SERVICE BULLETIN #1110

SUBJECT CRANKSHAFT IDENTIFICATION

MODEL 1-71 1-81 1-81 HD DATE 10/26/60
MC-6 MC-10 Kit

P/N 55765
Model 1-71, 1-81,
1-81 HD

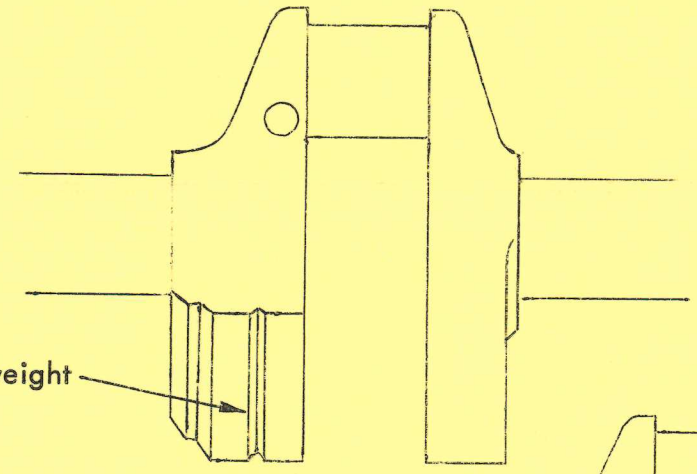
Groove is on the clutch end counterweight

P/N 48744
Model MC-6

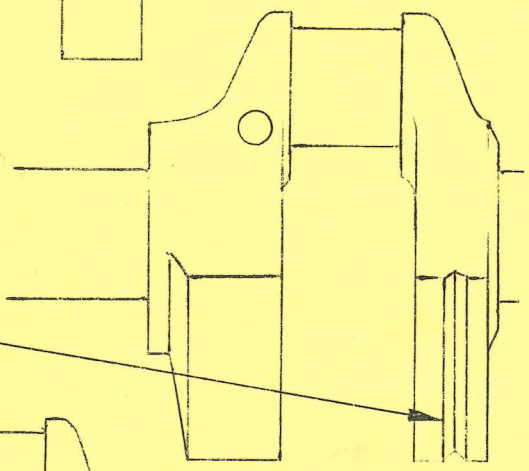
Groove is on the flywheel end counterweight

P/N 48696
MC-10 Power Kit

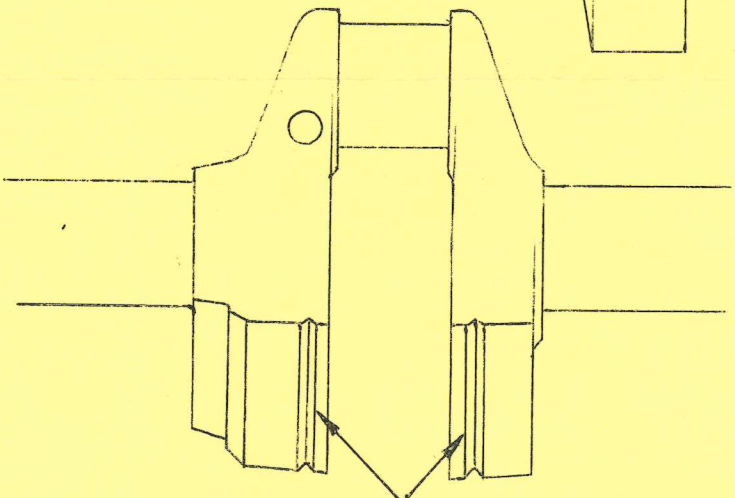
Grooves on both counterweights
